## Evaluation of Proposed Testing and Monitoring Activities at Carbon TerraVault's Monterey Formation A1-A2 Class VI Project

This testing and monitoring evaluation report for the proposed Carbon TerraVault (CTV)-Elk Hills Class VI geologic sequestration (GS) project summarizes EPA's review of the testing and monitoring the applicant proposes to conduct during and following injection operations into the Monterey Formation A1-A2 Sands. Due to the similarities of certain monitoring activities (e.g., groundwater monitoring and plume and pressure front tracking) to be performed in the injection and post-injection phases, these activities (as described in Attachments C and E of the Class VI permit application dated August 30, 2021, and Attachment E with information specific to well 355-7R submitted on December 3, 2021) are evaluated in a single report. This review identifies preliminary questions for the applicant, includes requests for supplemental information, and provides some considerations for future testing/analytical requirements. Note that, because of the interdependencies between the testing and monitoring strategy and other aspects of the permit application, additional questio

Figure 2 of the QASP shows the locations of all monitoring wells associated with the project and is reproduced below.

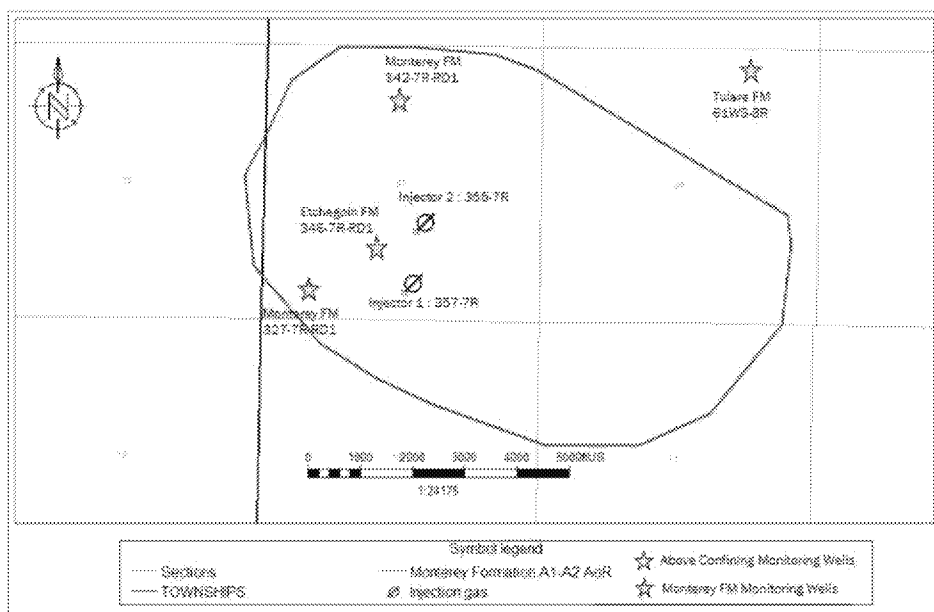
The Etchegoin Formation monitoring well appears to be situated within the AoR and in the anticipated path of the CO<sub>2</sub> plume and pressure front (based on information in Attachment B). The Upper/Lower Tulare Formation monitoring well is outside of the delineated AoR to the northeast of the injection wells, and down plume. Given that the Tulare Formation does not hold much water within the AoR, this location, while not in the same direction as the deeper monitoring wells may be most appropriate to allow geochemical sampling, although it is unlikely that CO<sub>2</sub> will travel that far down the limb of the anticline. CTV states that additional Upper Tulare monitoring wells will be drilled if increased pressure is observed in the Etchegoin Formation monitoring well or water quality changes in the Tulare Formation that is due to Monterey Formation A1-A2 CO<sub>2</sub> injection. However, it is unclear how a linkage of water quality/pressure changes to CO<sub>2</sub> injection (and not other activities) would be made.

- *Please explain the appropriateness of a single Tulare Formation monitoring well location relative to the anticipated direction of plume and pressure front movement, and, given the size of the injection operation. Additionally, please confirm that the predominant groundwater flow direction in the Tulare Formation is easterly. If flow direction is not easterly, provide an updated groundwater well monitoring plan that includes appropriate well placement in relation to groundwater flow direction.*

- Please include the groundwater monitoring well 61WS-8R in Figure 4 of the PISC and Site Closure Plan.
- Is Zalco laboratory a state-certified laboratory? Please note that EPA's Class VI UIC guidance recommends use of a laboratory that is state-certified.
